VILLAGE OF
BURR RIDGE
7660 COUNTY LINE ROAD
BURR RIDGE IL 60527

RE: January 20, 2025 Plan Commission Meeting Follow-up

Plan Commission Requested Information / Review Comments:

Development Review Comment Letter

C6.0

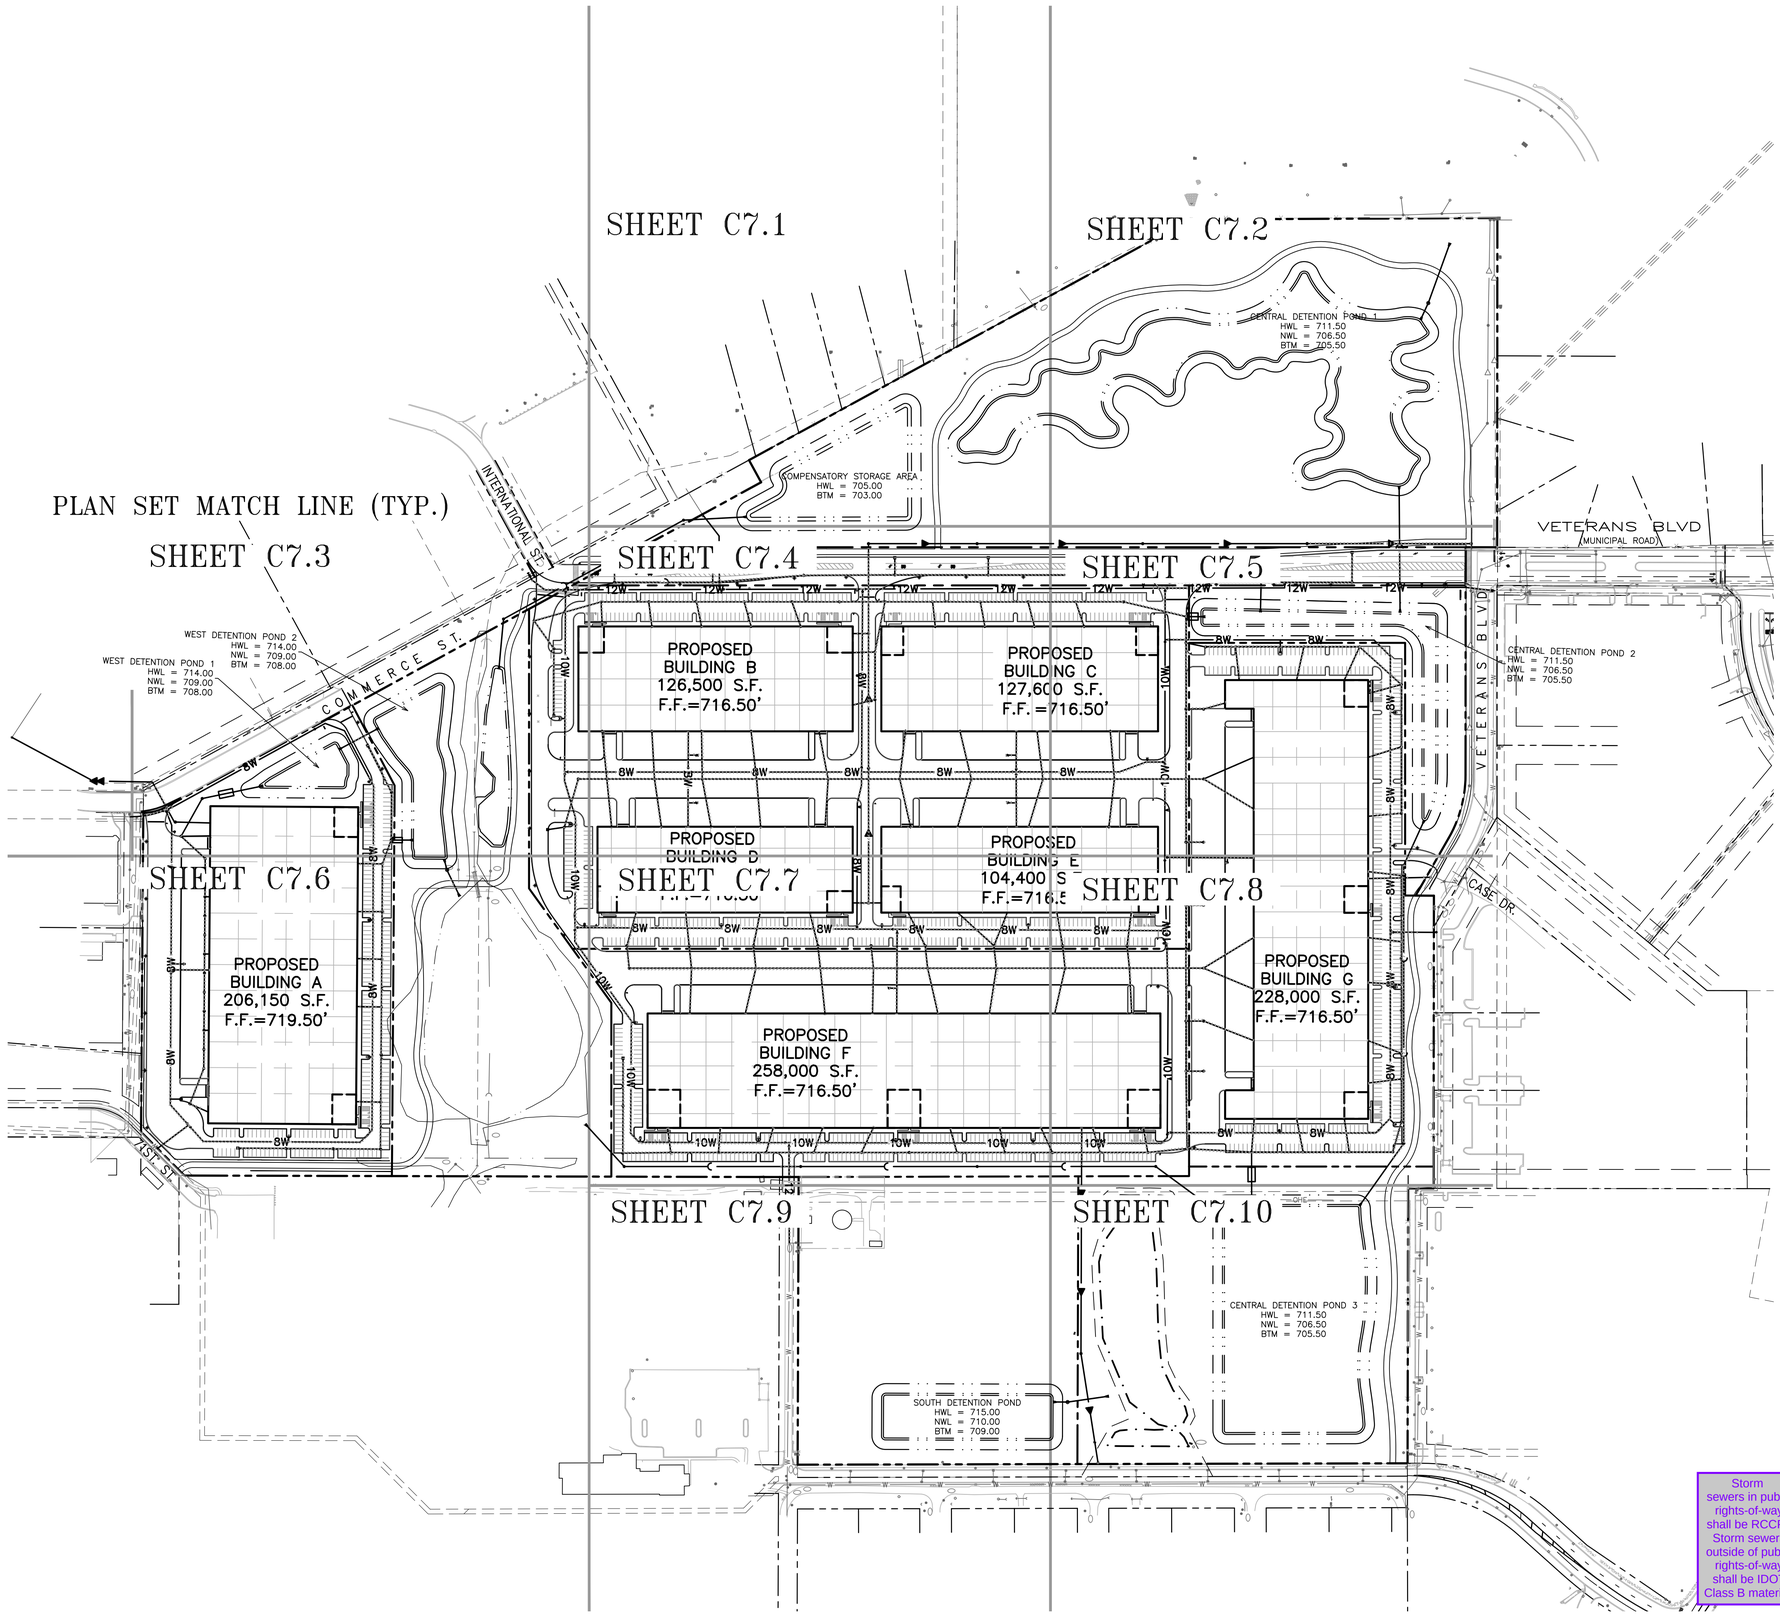
7) Please show all proposed dry utilities, connections, and transformers for coordination purposes.
8) Please update the graphic scale bar on sheet C6.0.

C6.5

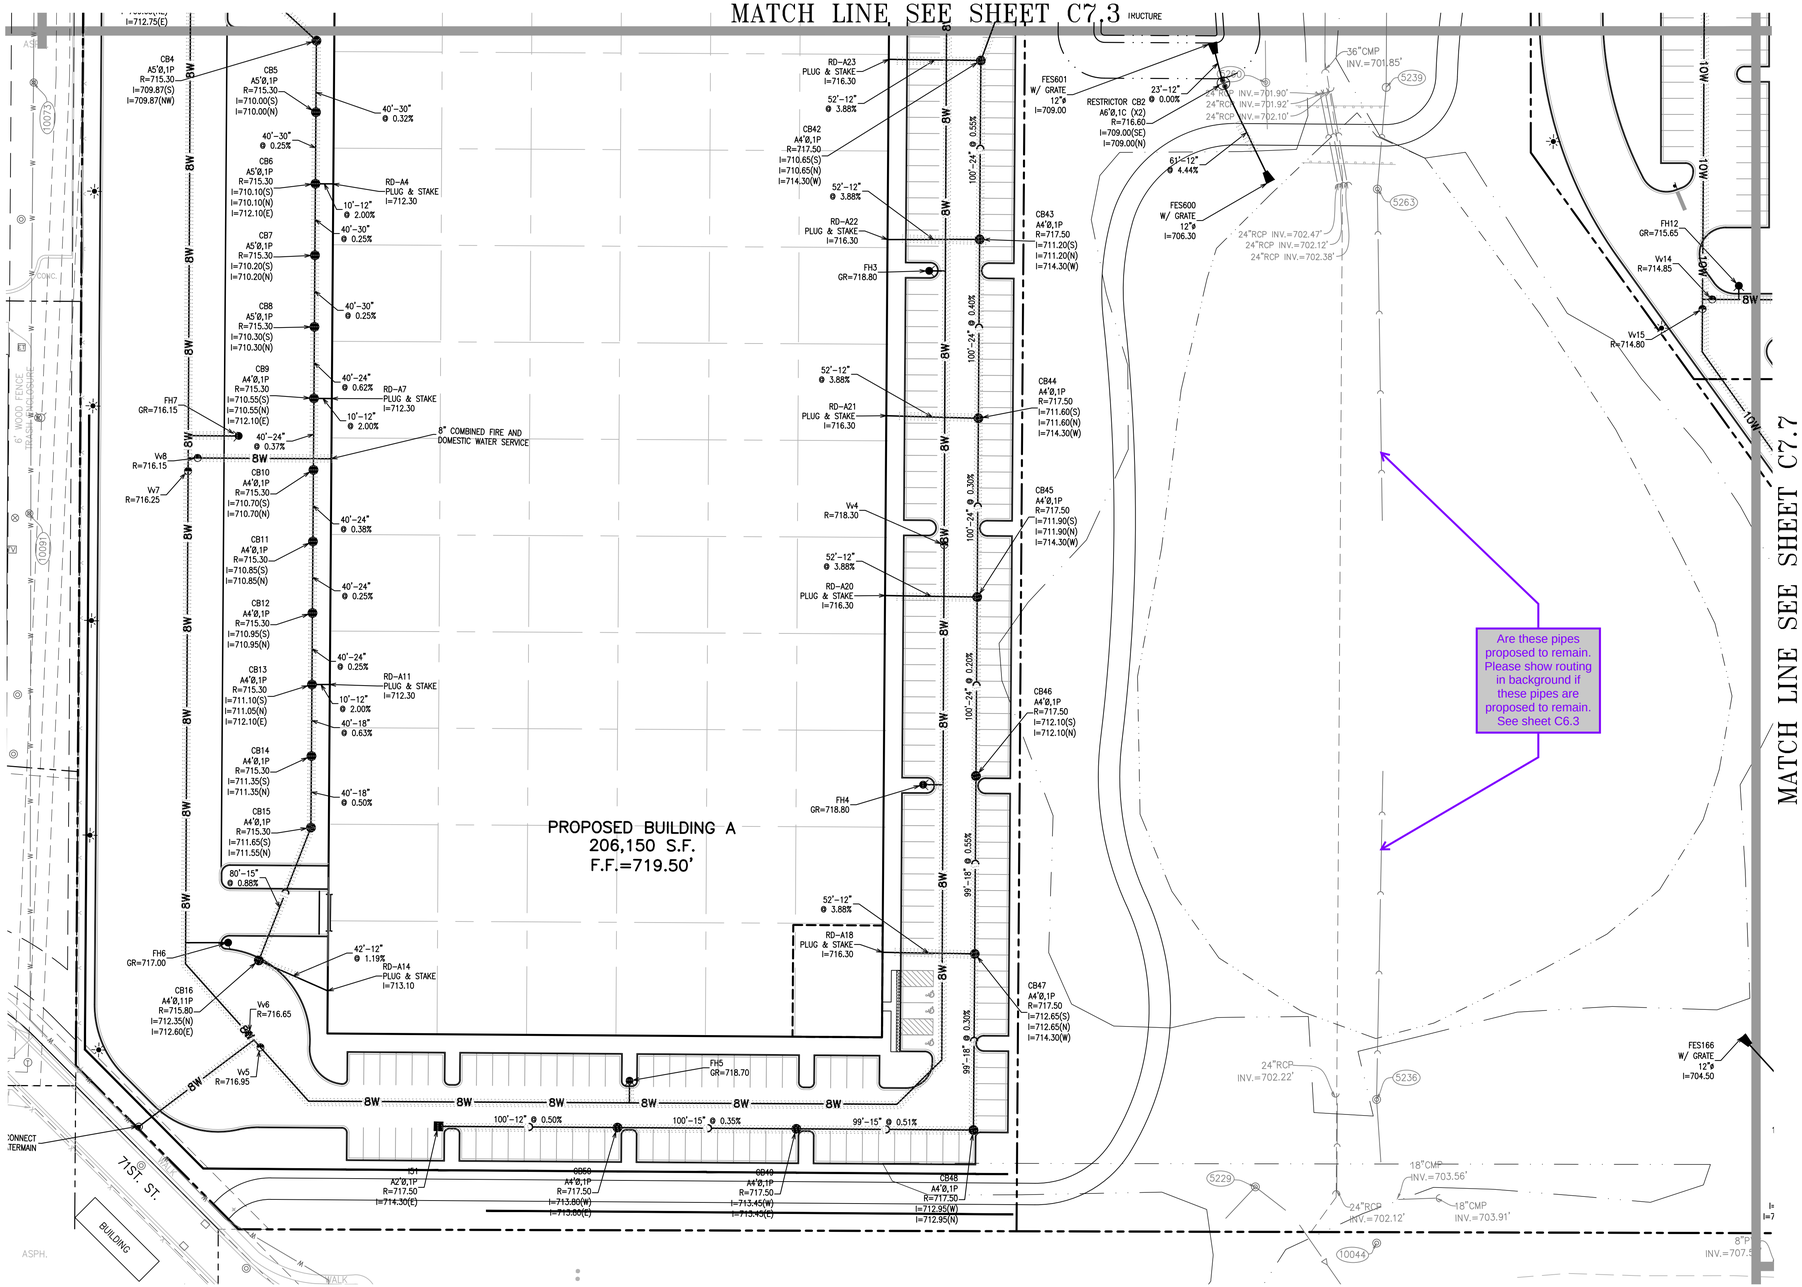
b. Provide horizontal separation for the watermain near Vv1 and Vv2 to the proposed sanitary force main on Sheet C6.3 as required by the IEPA.
    c. Provide horizontal separation for the watermain near Vv27 and the adjacent storm sewer as required by the IEPA (sheet C6.5).
